## Note of Footplate Inspection of Kavach installation in ECR on 12.06.2024 by Lalit K Mansukhani, OSD/CoE(Modern Signalling-Kavach)

Inspection through footplate on Kavach fitted Loco Movement was carried out in Up and Down Directions in Section from Anugrah Narayan Road to Deo Road and back. Section and Onboard Kavach and RFID Tag formats - all were latest Draft Ver 4.0 (Unapproved) as on day of Inspection.

IRISET/CoE/Kavach/Misc 03.07.2024

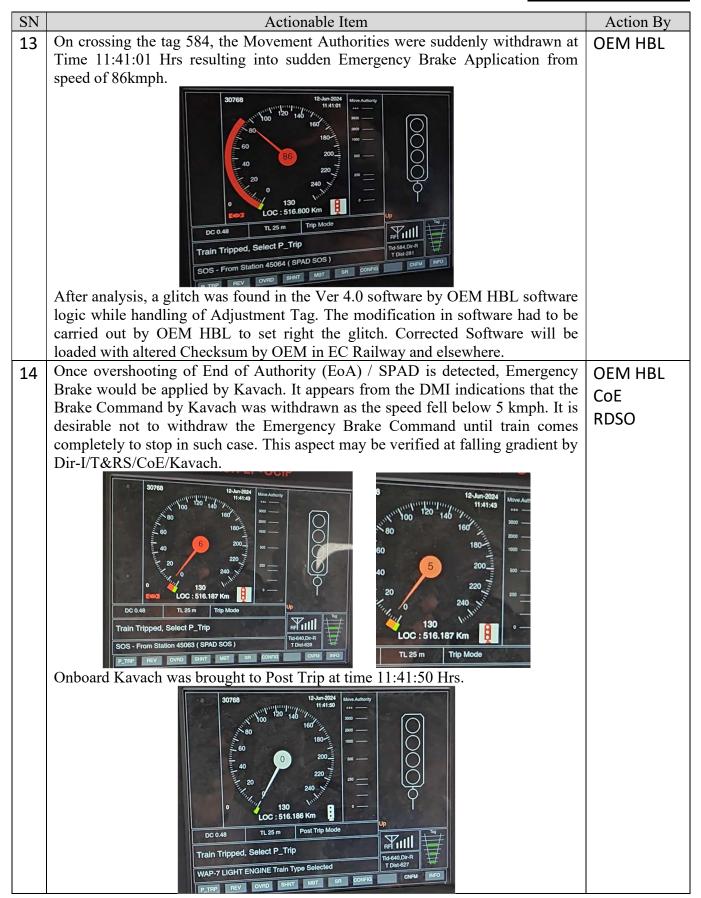
9 On invoking Override at km 519.338, the Onboard Kavach immediately entered in On Sight (OS) Mode with display of On Sight Movement Authority.

Further, the Authority (1,365 m) displayed was corresponding to Mainline (S6 at km 517.973). 519.338km - 517.973km = 1,365m

The train was actually routed to Loopline. On investigation through conventional signalling datalogger, it was learnt that the route was not locked while giving Movement Authority, therefore it could be altered by Station Master to Common Loopline (S4 at 517.965km) after giving Movement Authority.

The Authority Distance is subsequently adjusted in non-radio based ETCS L-1 through Repositioning Balise. The Aspect of the signal at divergence (such as Calling-On Signal) is not able to distinguish between locked routes in

ETCS Level-1. Therefore, the relevance of Repositioning Balise in radio-based ETCS L-2 is not same as in ETCS L-1. Same applies to radio-based Kavach.

It was learnt on investigation through Signalling Datalogger that the route was not locked and the LC Gate also was open initially. On seeing approaching Locomotive, Gateman lowered the booms.

Kavach unduly provided Movement Authority without ensuring locking of route, closure of LC Gate to Road Traffic i.e without actually having authority. This needs design modification. CoE has advised RDSO for not giving Movement Authority without protection by route (latest reiteration vide letter 19.01.2024). This is in line with the fact that any lineside signals provide protection and authority beyond its location (not on its approach). Moreover, Kavach displayed Movement Authority distance to Train Pilot in On Sight Mode as newly introduced "feature" in Kavach Ver 4 Spec.
